Claims 1-11, 13-16, and 18-28 are pending. Reconsideration and allowance are respectfully requested in light of the following remarks.

Rejection under 35 U.S.C. §112

Restriction Requirement and Drawings

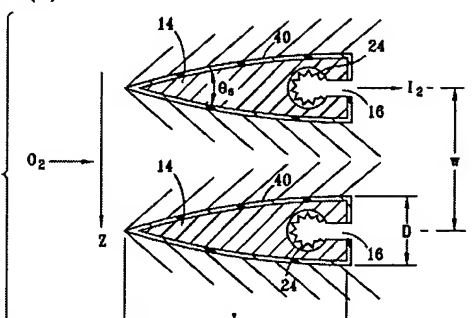
Another Replacement Sheet of Figure 1 has been included, wherein the following text has been added:

“I₂, and optionally an N₂ or He carrier.”

With respect to the term “laser cavity” in Claim 1, Applicant respectfully points the Examiner’s attention to Figure 1. Reference numeral 18 is defined as being a “laser cavity” (see page 15, line 15, of the originally filed Application). Clearly, Applicant is reciting the “laser cavity” as defined in the originally filed Application. Therefore, Applicant respectfully asserts that the recitation is clear.

Regarding items 6, 11, and 12, Applicant previously amended Figure 1 to include the missing features. However, Applicant has, again, amended Figure 1 to include these features in case previous amendments to Figure 1 have not been entered. Accordingly, Applicant respectfully requests that the objections to the drawings for items 6, 11, and 12 be withdrawn.

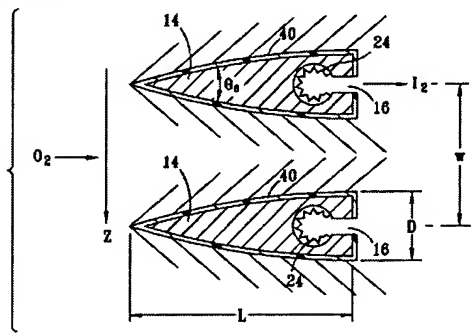
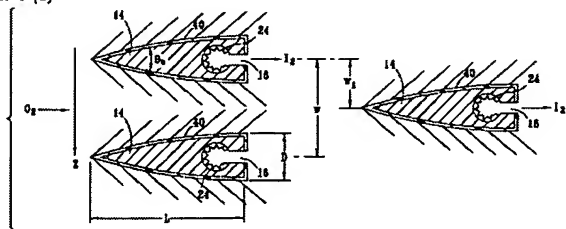
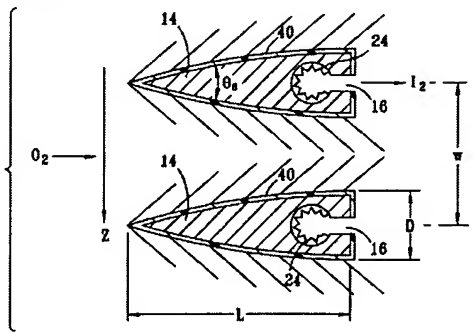
Figures 4 and 5 had been previously withdrawn from reconsideration. However, Applicant seeks to reintroduce Figures 4 and 5. MPEP §809.02(c) reads as follows:

Because Figures 4 and 5 have been reintroduced, items 1-5, 7-10, and 13-15 are depicted in Figs. 4 and 5. Applicant has provided the table below explicitly showing each of these features in the drawings for claims that have not been cancelled.

Item No.	Item	Drawing	Specification
1	sharp wedge with an angle less than 45°	<p>FIG. 4 (a)</p> 	<p>“The angle θ_s preferably ranges from 5° to 45°, and most preferably is around 20° or less.”</p> <p>Pg 27, lns. 7-8.</p>
2	sharp wedge with an angle less than 20°		
3	struts has a coating		<p>“The struts have a coating 40 and have</p>

necessary or desired.” Pg. 27, lns 10-13
10	sharp ogive	Claim has been cancelled	
13	two struts	<p><i>FIG. 4 (a)</i></p> 	<p>“FIGURE 4(a) shows two struts, in cross-sectional top view. The iodine flows through feed duct 20 and exits through orifice 16. The oxygen gas flow direction is shown as well as the optical direction, denoted as z in FIGURE 4(a). The spacing between adjacent struts is w.”</p> <p>Pg. 27, lns. 1-5</p>
14	two struts are staggered	<p><i>FIG. 4 (b)</i></p> 	<p>“FIGURES 4(b) and 4(c) show cross sectional top views of alternate embodiments where the struts 14 are staggered.”</p> <p>Pg. 36, lns. 1-2</p>
15	heating element	<p><i>FIG. 4 (a)</i></p> 	<p>“The struts have a coating 40 and have heater elements 24.”</p> <p>Pg. 35, lns. 20-21</p>

Therefore, Applicant respectfully requests that the objections to the drawings for items 1-5, 7-10, and 13-15 be withdrawn.
